Re: Draft Environmental Impact Statement: Update of the Water Control Manual for the Apalachicola-Chattahoochee-Flint River Basin in Alabama, Florida, and Georgia and a Water Supply Storage Assessment (Oct. 2015)

Thank you for the opportunity to comment on the Draft Environmental Impact Statement: Update of the Water Control Manual for the Apalachicola-Chattahoochee-Flint River Basin in Alabama, Florida, and Georgia and a Water Supply Storage Assessment (Oct. 2015) (the "Draft EIS"). These comments are submitted on behalf of the water supply providers in the metropolitan Atlanta region including: the Atlanta Regional Commission; the City of Atlanta; the Atlanta-Fulton County Water Resources Commission; the Cobb County-Marietta Water Authority; DeKalb County; Forsyth County; Fulton County; Gwinnett County; and, the City of Gainesville (collectively, the "Water Supply Providers").

**Figure 1. Lake Lanier Stage:
Revised 2050 Demands v. Army PAA**

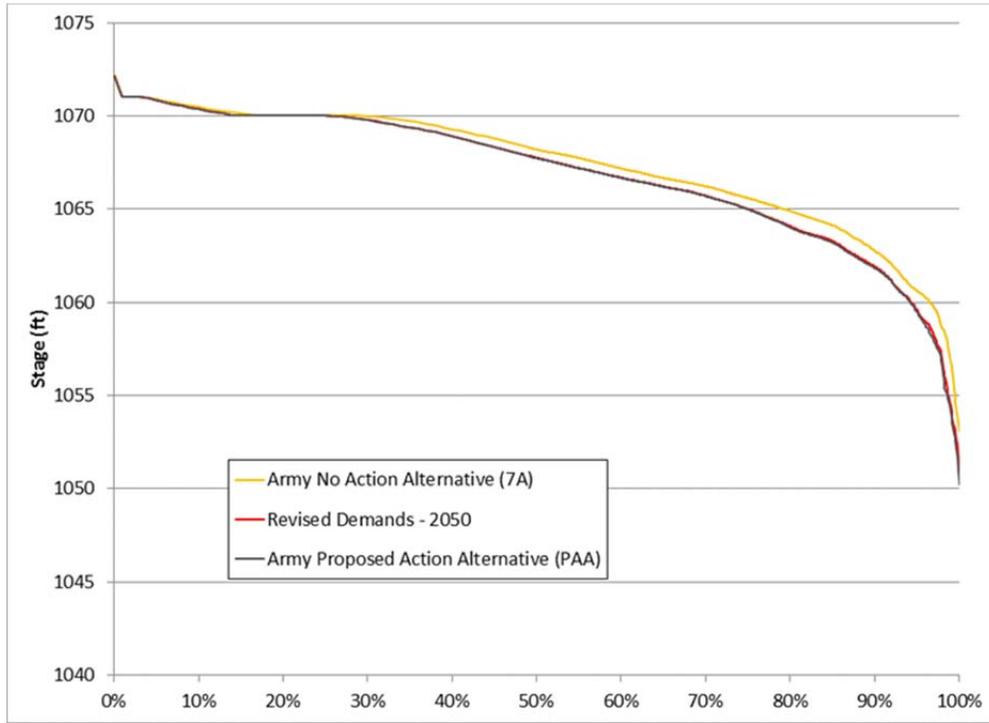
Across the board, lake levels would be about the same when the Revised 2050 Demand is met than under the Army's Proposed Action Alternative in the Draft EIS.³⁷ Results for Lake Lanier—the reservoir most likely to be affected by increased water supply demands—are shown below in Figure 1 and Figure 2. As can be seen, the difference is almost imperceptible (Figure 1). The percent of time Lake Lanier would be in Zone 1 is unchanged under the Revised Demands - 2050 scenario, compared to the Army's Proposed Action Alternative. Further, according to the Army's model, the minimum stage under the worst droughts in the hydrologic record would actually be slightly higher (Figure 2) (1050.8 for the Revised Demands - 2050 scenario, compared to 1050.2 for the Army's PAA reported in the Draft EIS).

**Figure 5. Chattahoochee Gage Flows:
Revised 2050 Demands vs Army PAA**

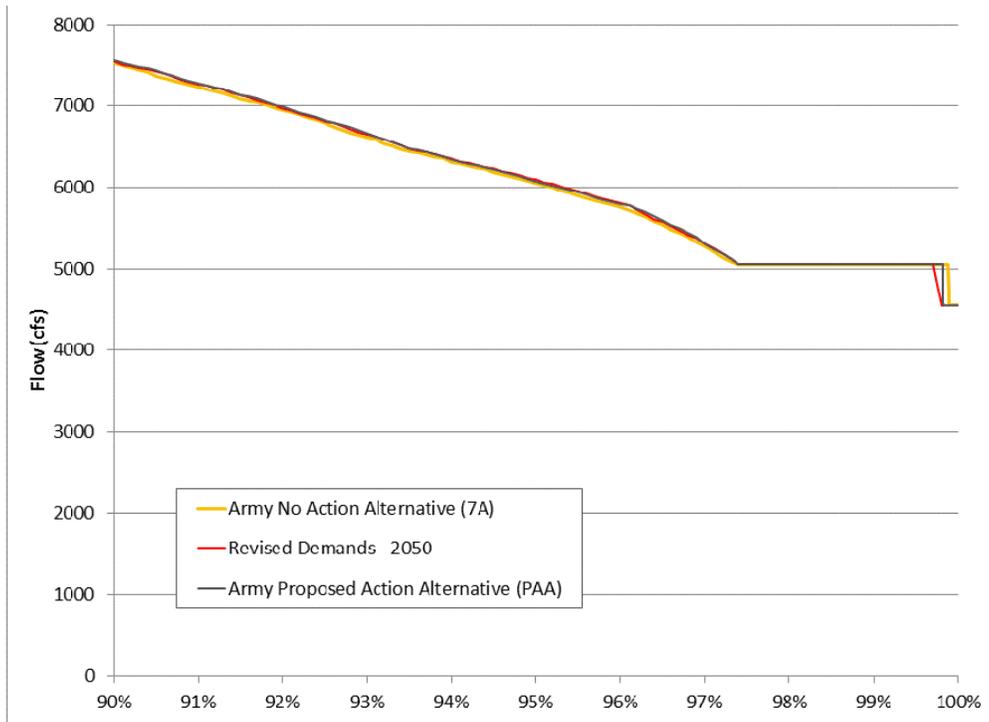
Consistent with the Army’s conclusion that water supply operations “do not have an appreciable effect on flow conditions in the Apalachicola River,”³⁹ flows at the Chattahoochee gage in Florida are virtually identical when the Revised 2050 Demands are met. As the figures below show, flows would increase slightly in the 5,000 cfs to 8,000 cfs range, while the number of days with flows less than 5,000 cfs would increase by just one tenth of one percent—0.3% of days when the Revised 2050 Demands are met, compared to 0.2% under the Army’s Proposed Action Alternative (Figure 5). Even under the worst drought in history, Apalachicola River discharges at the Chattahoochee gage under each scenario are essentially equivalent when the Revised 2050 Demands are met (Figure 6).

Figure 7. Cumulative Flow at the Blountstown Gage Compared to Comparable Area Gages

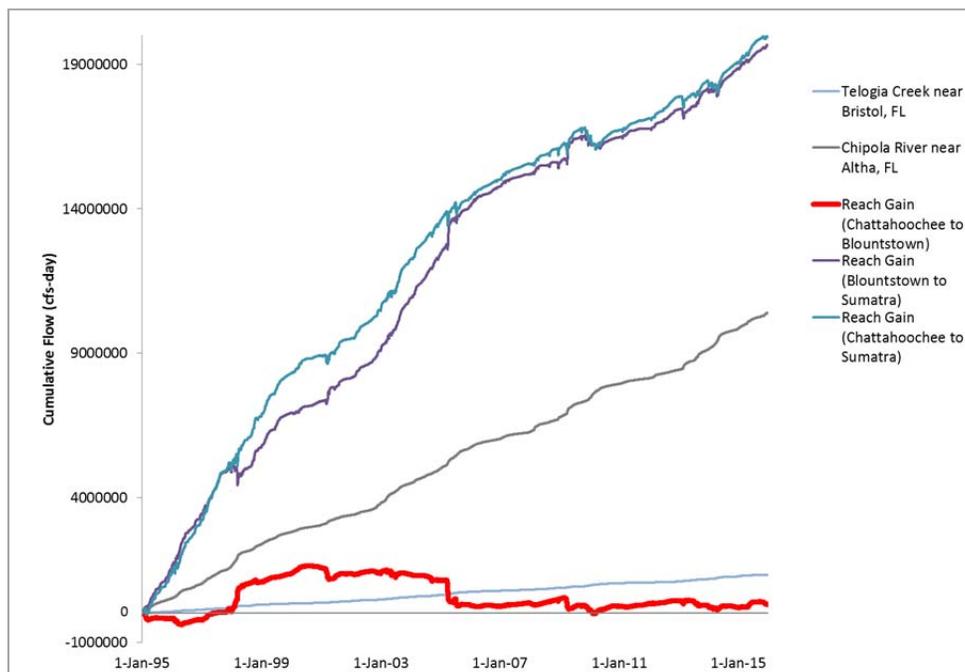
The plan assumes that a 7-foot channel will be available whenever the flow at the Blountstown gage is at least 16,200 cfs. A close look at the data from that gage reveals why the plan will not work. Figure 7 shows the cumulative flow at the Blountstown gage compared to other gages in the area.

“Cumulative flow” is the sum total of all water flowing past a gage. So long as tributary inflow to a given stream reach exceeds withdrawals and other losses, this number should always increase over time. It should also be roughly linear, with the slope over a given period being equal to the average inflow over that same period. Other gages near Blountstown show the

The most plausible explanation for the erratic relationship between flows and gage height in the Blountstown reach is that water is bypassing the Blountstown gage outside of the gaged river channel. This might be caused by any number of conditions, including changes in river channel morphology, breaches in natural levies, and/or the silting in of bypass channels. But whatever the cause, it means that the Army cannot ensure that releases intended to provide a certain flow will be contained within the navigable channel, or that the channel depth the Army intends to provide will actually be present. This issue must be thoroughly investigated before any decision to support navigation is made.

**Figure 8. Chattahoochee to Sumatra Reach Gains:
1977-1990 vs. 2002-2015**

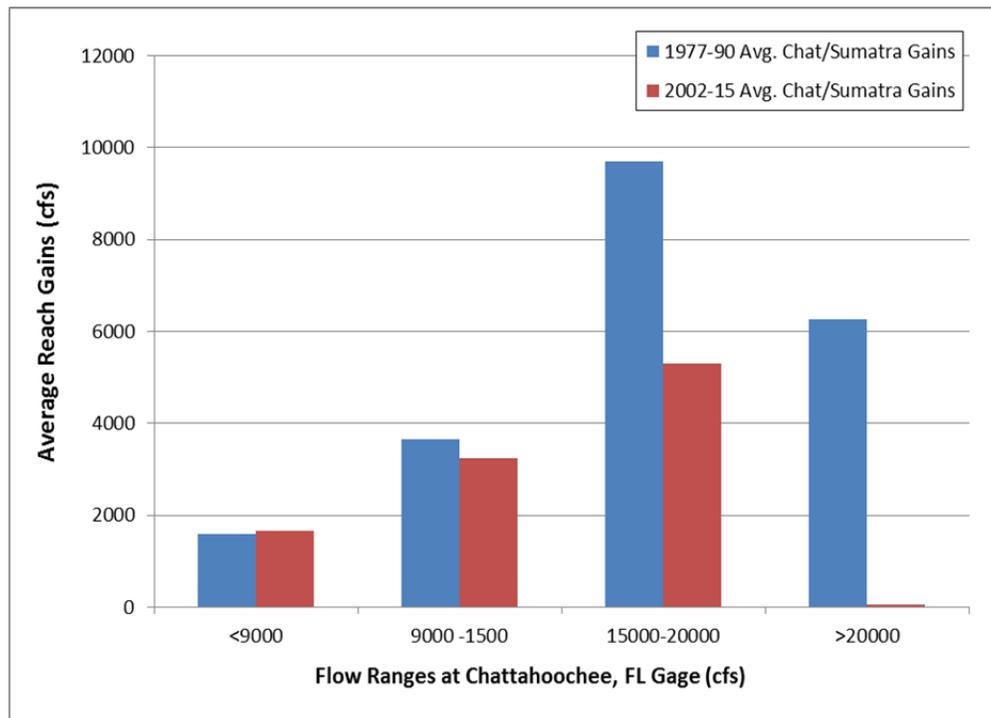
All of the Army's navigation modeling assumes that historical flow patterns will be representative of future flow patterns. This is obviously a flawed assumption for these downstream reaches, where clear trends suggest that future inflows will be far lower than those experienced previously.

At a minimum, the gage data show that far more water may need to be released to support a 7-foot channel than the Draft EIS anticipates. At worst, the data show structural problems that must be fixed before navigation can be supported. Any attempt to support navigation through reservoir releases alone, without first addressing these problems, could result in the Army releasing huge volumes of water to maintain a channel that will never fill. The situation will get worse over time as the channel continues to deteriorate.

Figure 9. Impacts of Navigation Releases on Lake Lanier

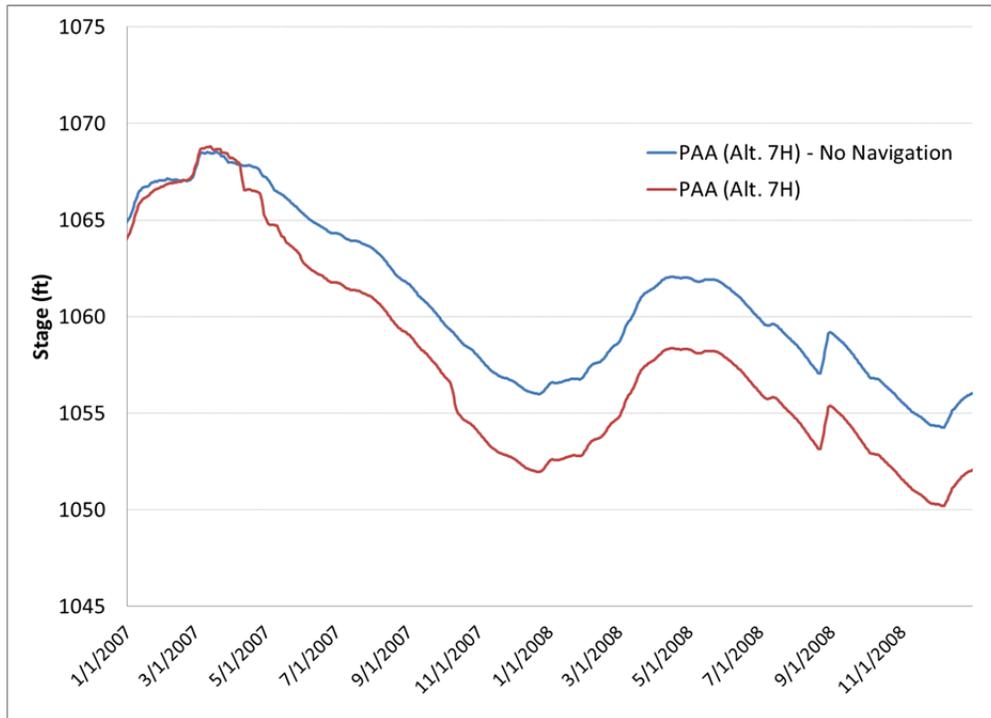
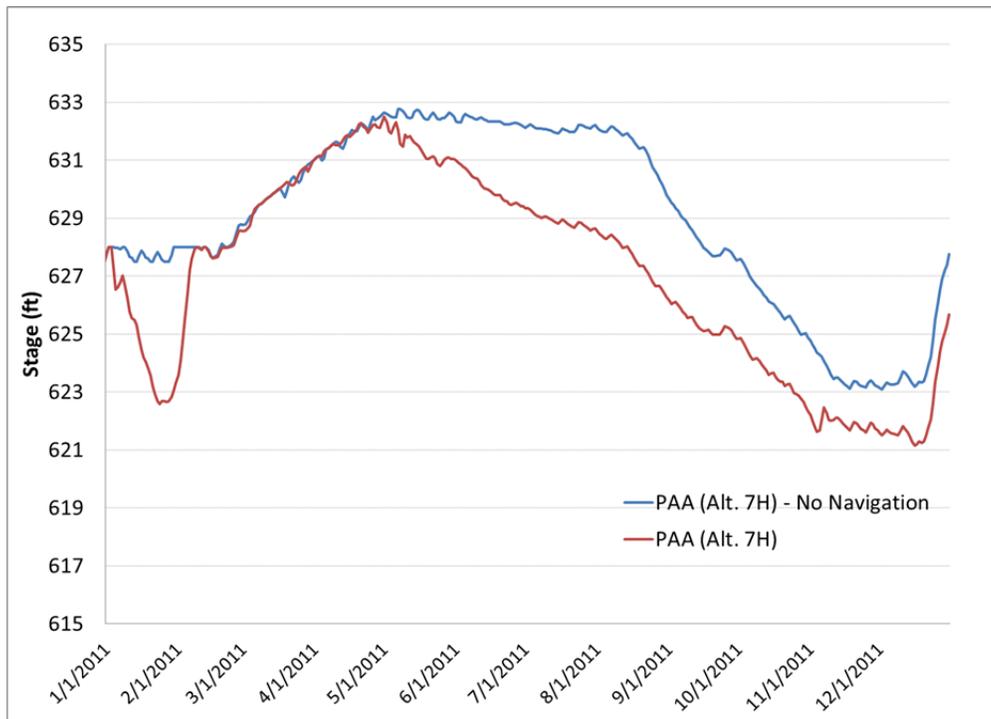
As shown below, the navigation plan in the Proposed Action Alternative will cause reservoirs to be significantly lower during droughts and nearly double the frequency of drought operations. The Army’s own ResSim model confirms that navigation releases would be made during the most severe droughts in history, with predictable results. In 2007-2008, for example, as depicted in Figure 9 below, the ResSim model shows a 4.1-foot impact to Lake Lanier. West Point Lake would also be lowered by 1.7 feet. The impact under 2011 conditions would be even more pronounced system-wide, reducing Lake Lanier by 3.6 feet and West Point by 5.1 feet (Figure 10). The proposed navigation plan would almost double the number of times the drought operations are triggered—from 13 to 22—compared to operations when navigation support is removed.

Figure 11. Potential Reductions in Flood Peak at West Point from Operational Changes

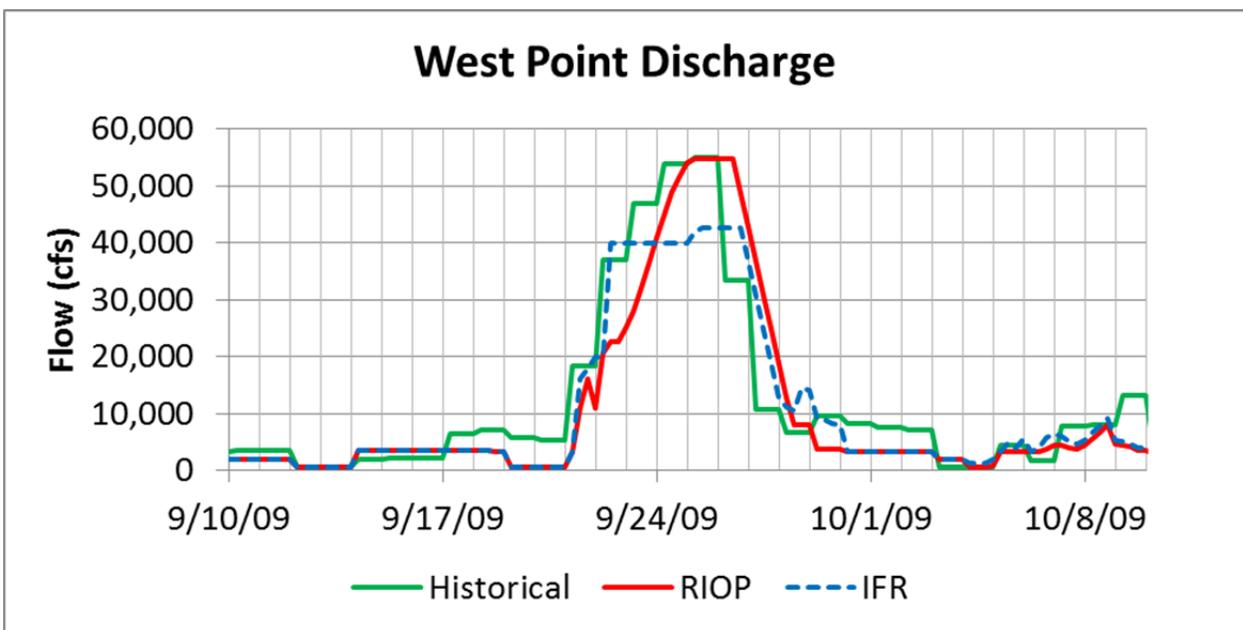
Work performed for Georgia EPD has shown that existing flood storage in West Point can be operated more effectively, allowing the Army to provide equivalent flood protection with less available flood storage.¹²⁴ This is achieved by incorporating readily available forecasts to adjust releases from the reservoir in advance of flood events. This allows the Army to anticipate inflows to the project and to release water accordingly, thereby preserving available flood storage to store flood waters when they enter the project.

Figure 11 below shows the modeled flood peaks at West Point compared to actual reservoir levels during the 2009 flood event. As can be seen, the projected flood peak is reduced in the “IFR” (or “inflow following rule”) run compared to both the Army’s historical operations and its modeled operations under the Revised Interim Operating Plan. This demonstrates that the flood protection provided by a given volume of flood storage can be improved with better operating rules. It follows that the winter drawdown could be reduced—thus, reducing the quantity of flood storage available—without necessarily increasing flood risks, as the Army assumed in refusing to consider this alternative.

Figure 12. Disproportionate Recreation Impacts Under Current Action Zones

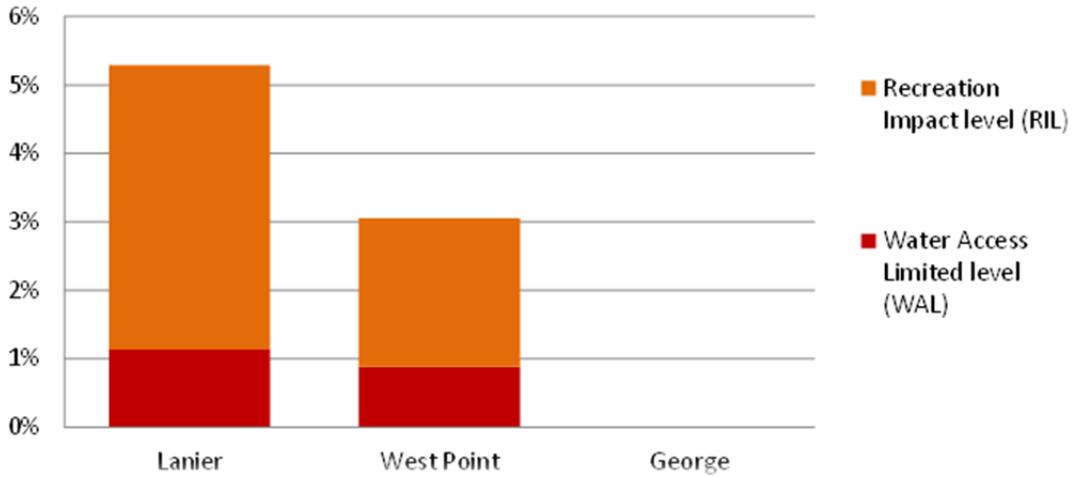
We support the Army's proposal to redefine the reservoir action zones based on each reservoir's drainage area. The Water Supply Providers have long explained that the current action zones disproportionately impact Lake Lanier and fail to recognize its unique character as a large headwaters reservoir with just 5.6% of the ACF Basin's drainage area. This is clear from Figure 12 below which shows recreation impacts under the current action zones (RIOP, 2011 demands).¹²⁶ As can be seen, the current action zones subject Lake Lanier to Level 2 or 3 recreation impact (below Recreation Impact Level, RIL) substantially more than either West Point or Walter F. George.

Figure 13. Refill Response of Federal Reservoirs During 2007 Drought

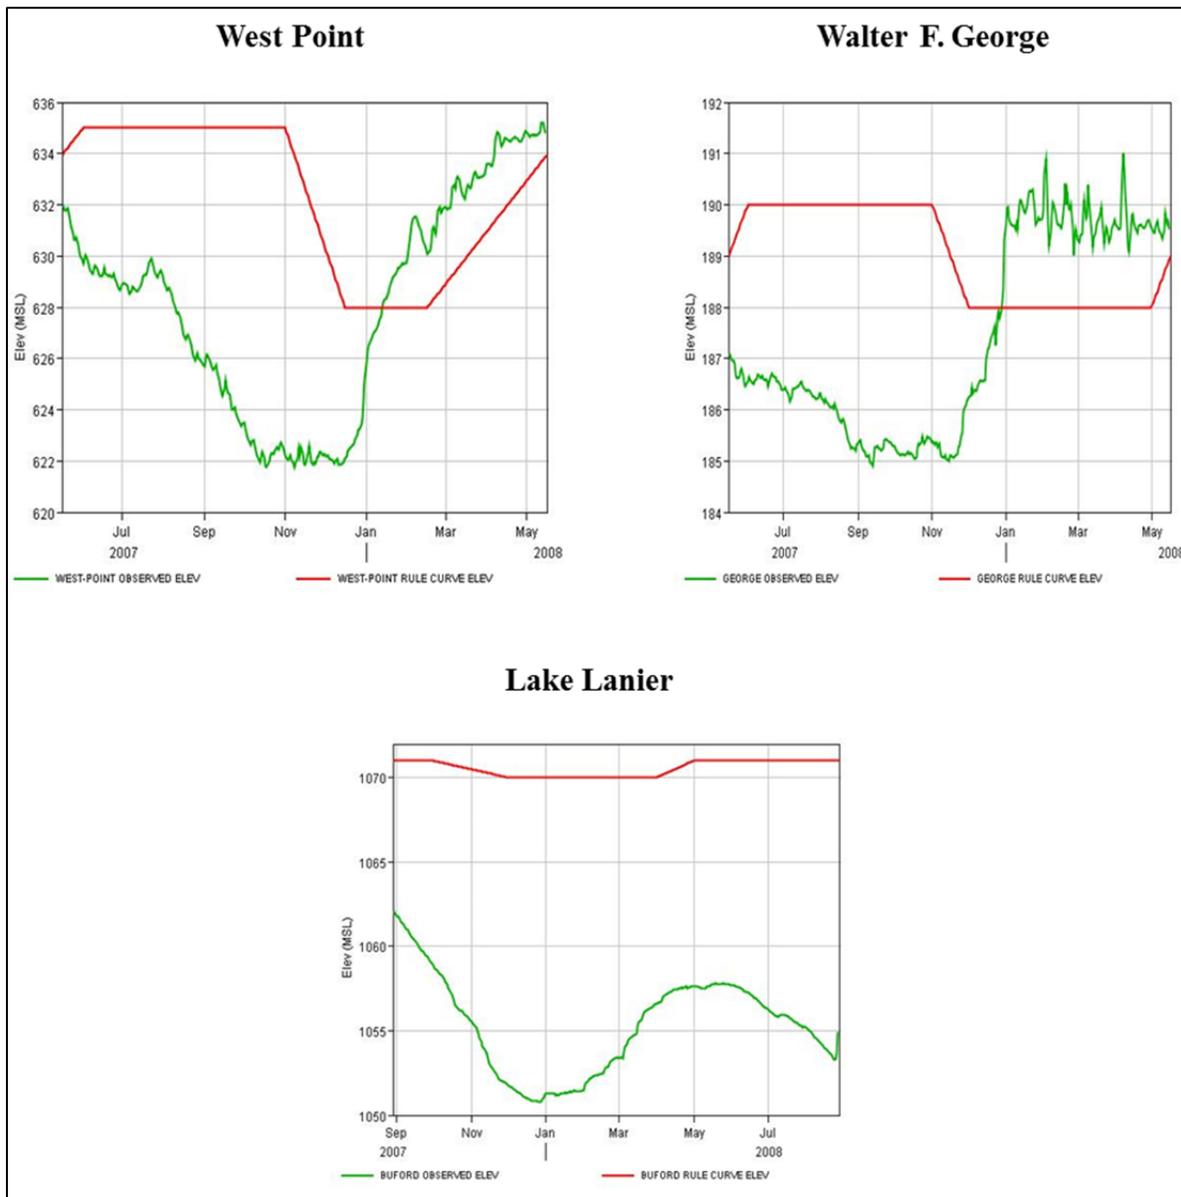
Further, the Army's current action zones failed to acknowledge real differences between the federal reservoirs, namely Lake Lanier's comparatively limited refill capacity relative to the lower reservoirs due to its large storage volume and small drainage area. This is clear from the 2007 drought, when the lower projects recovered almost immediately due to a rain event and their large drainage areas while Lake Lanier languished at low levels and entered the second year of the drought at very low levels.
